# ALTURA FARMS FILING NO. 2 SITE PLAN

Altura Farms Subdivision Filing No. 2,  
 Being a part of the Northwest 1/4 of Section 5,  
 Township 4 South, Range 66 West of the 6th P.M.,  
 City of Aurora, County of Arapahoe, State of Colorado

**UTILITY & GRADING PLAN**

**ALTURA FARMS SUBDIVISION FILING 2**

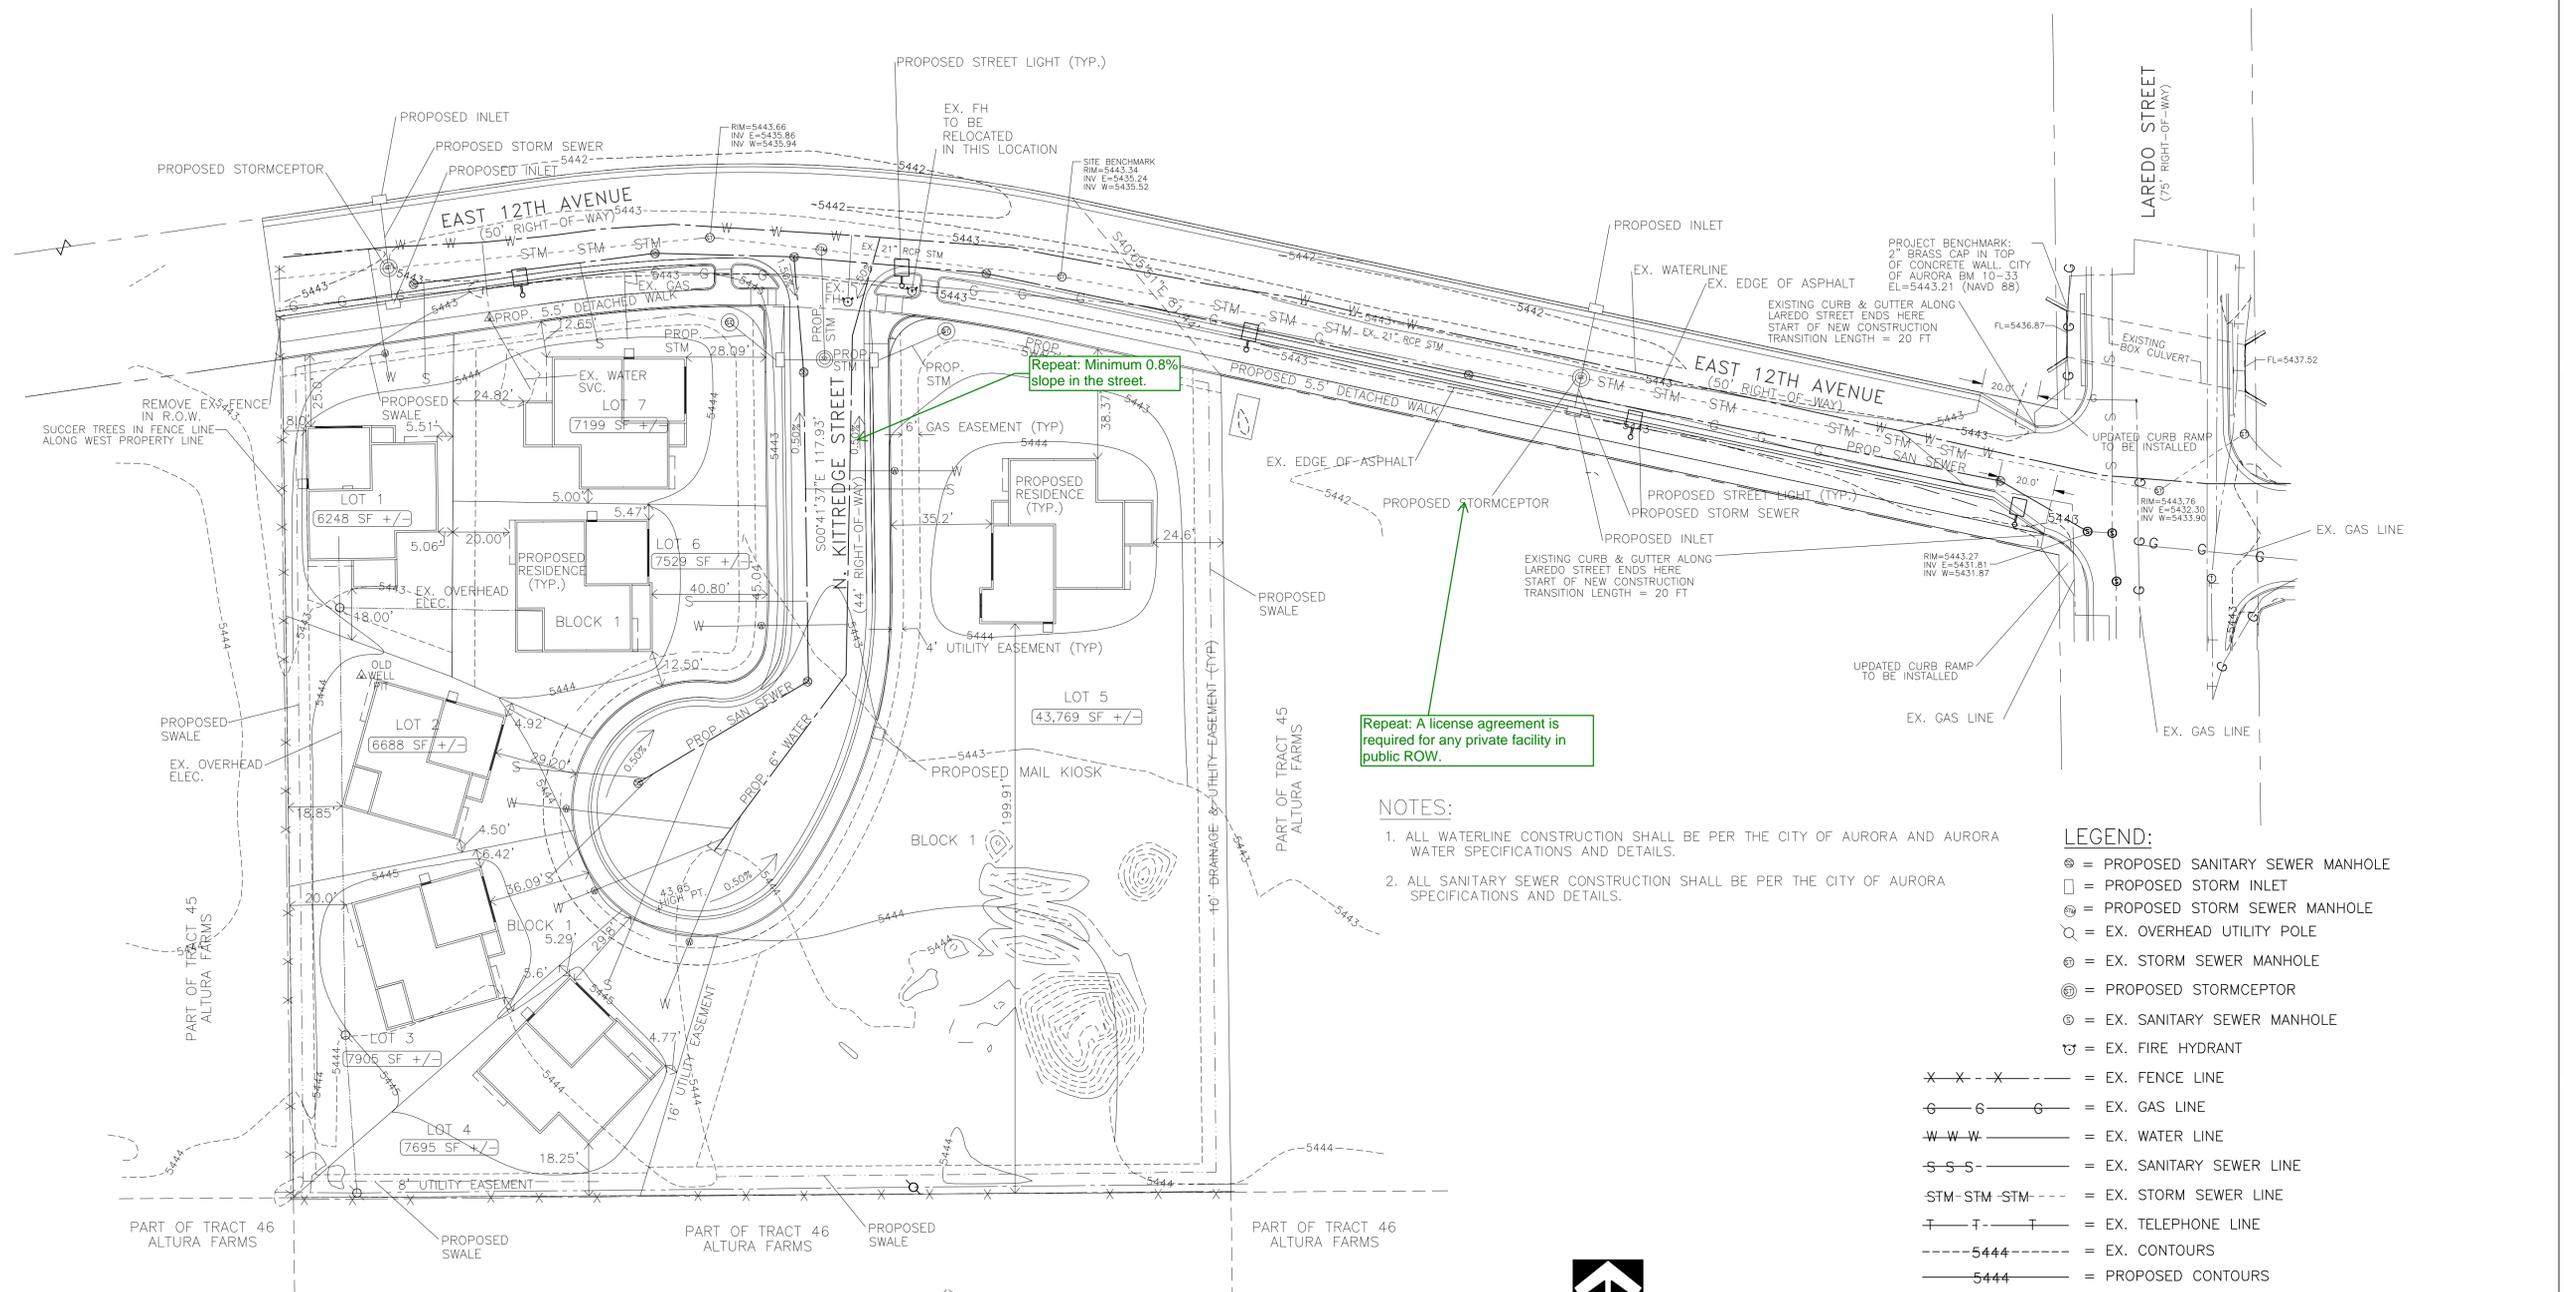
Repeat: Minimum 0.8% slope in the street.

Repeat: A license agreement is required for any private facility in public ROW.

**TREE MITIGATION PLAN**

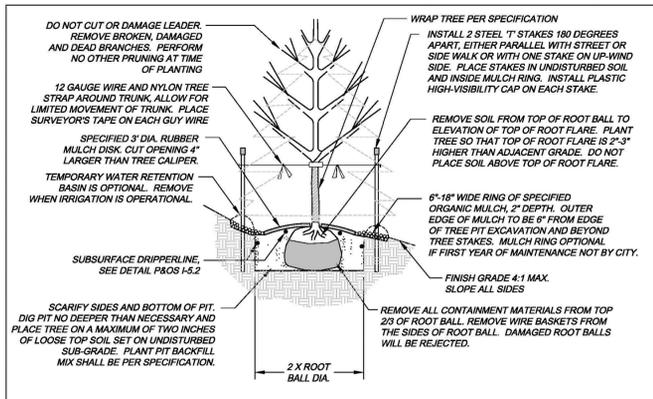
Trees that are being provided to meet landscape requirements may not be counted toward tree mitigation only the inches that are above and beyond the minimum tree sizes. If a 2" is required and 2.5" is provided, then the .5" can be counted toward mitigation. Having said that, there are not 28 mitigation trees being provided. Payment into the tree planting fund is likely necessary.

Please contact Aurora Forestry. Edit tree mitigation table, 25" of mitigation is required back on site. The table is a series of formulas which calculate mitigation inches.  
Please show a symbol indicating trees that are specific to tree mitigation on the landscape plan. Mitigation is always over and above existing landscape code requirements.

3 PERENNIAL PLANT LAYOUT

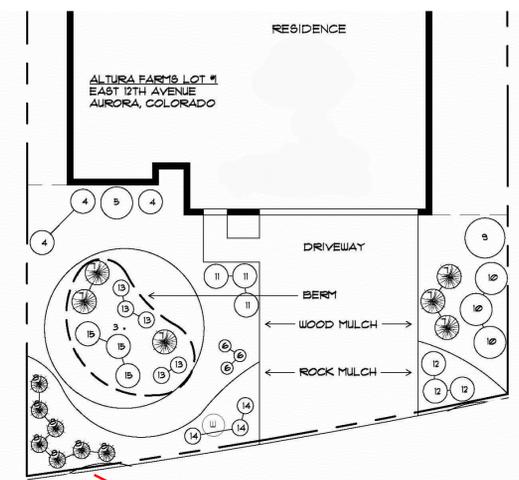
Include the street for context. Label the street E. 12th Avenue

5 LOT #1 LANDSCAPE

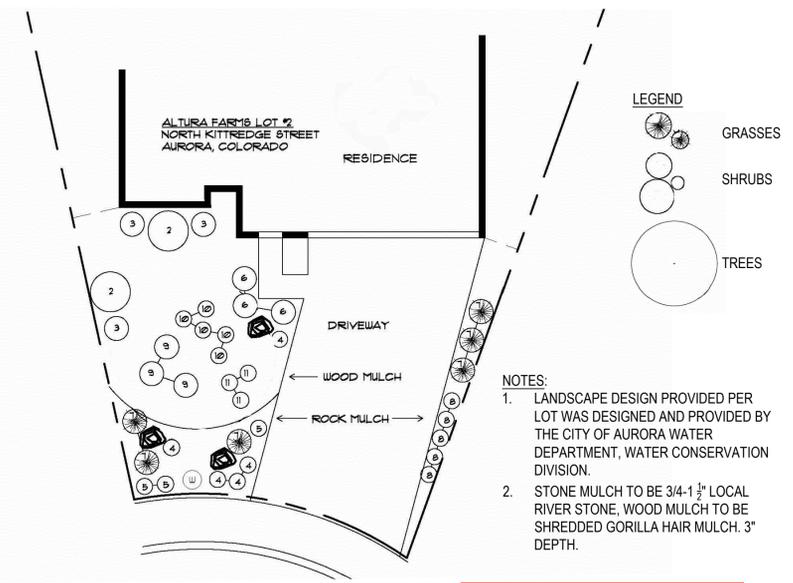
Add the street name: N. Kittredge Street.

7 LOT #3 LANDSCAPE

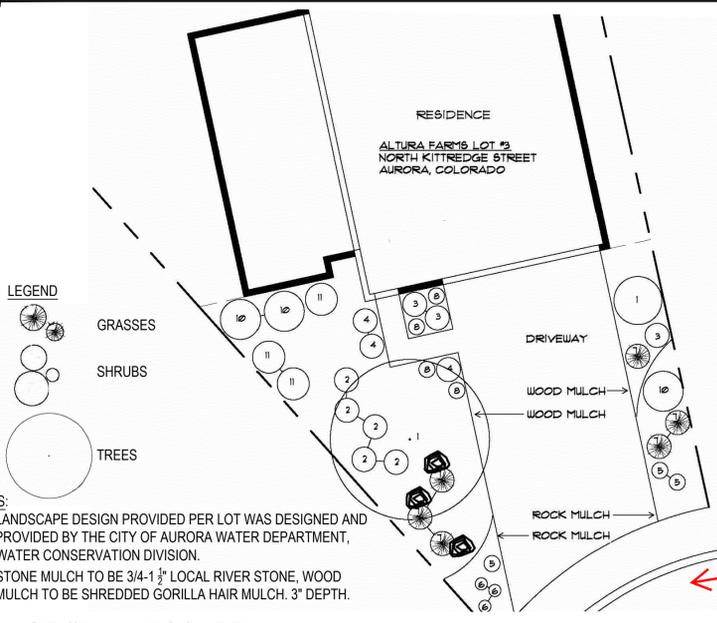
Please set the sheets up so that the plant list for the respective lot is beneath the lot typical design.

Add the street name: N. Kittredge Street.

**LANDSCAPE DETAILS**

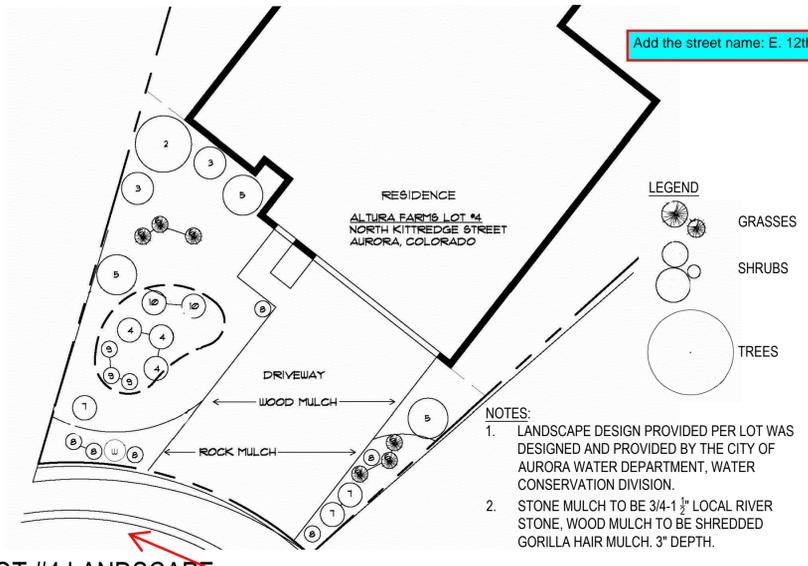
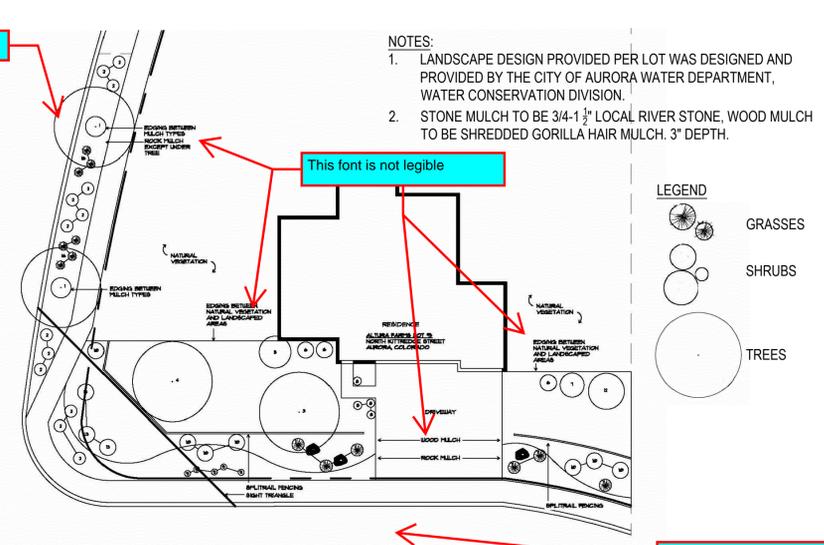
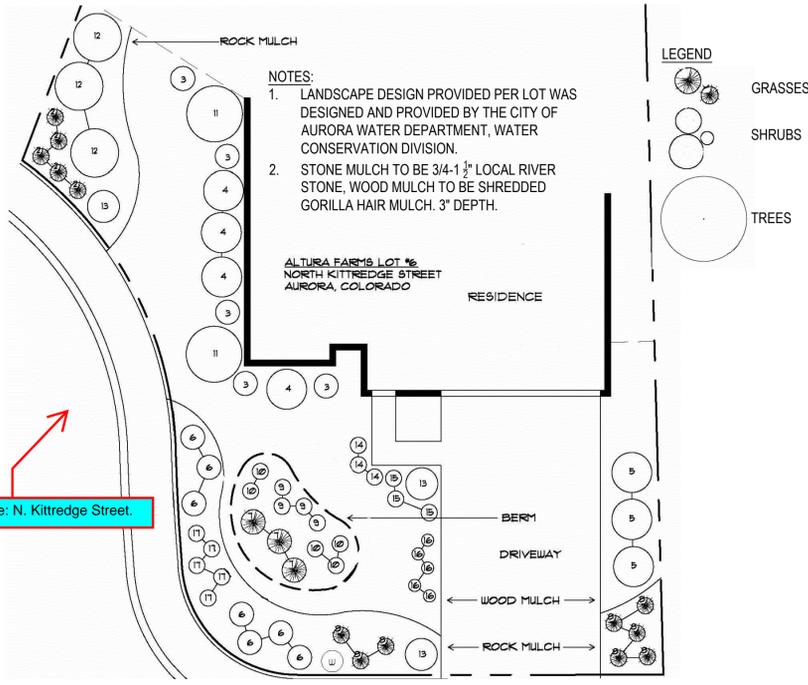
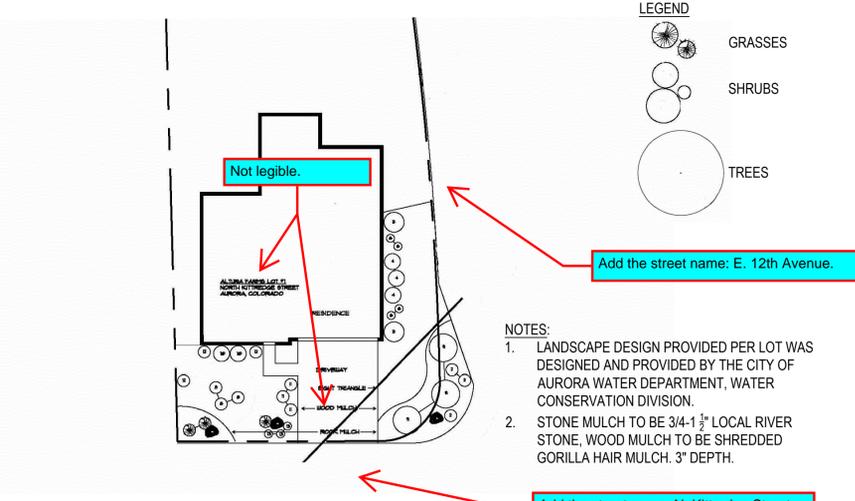
Add the street name: N. Kittredge Street.

Add the street name: N. Kittredge Street.

Add the street name: N. Kittredge Street.

Add the street name: E. 12th Avenue.

This font is not legible

Add the street name: E. 12th Avenue.

Add the street name: N. Kittredge Street.

Not legible.
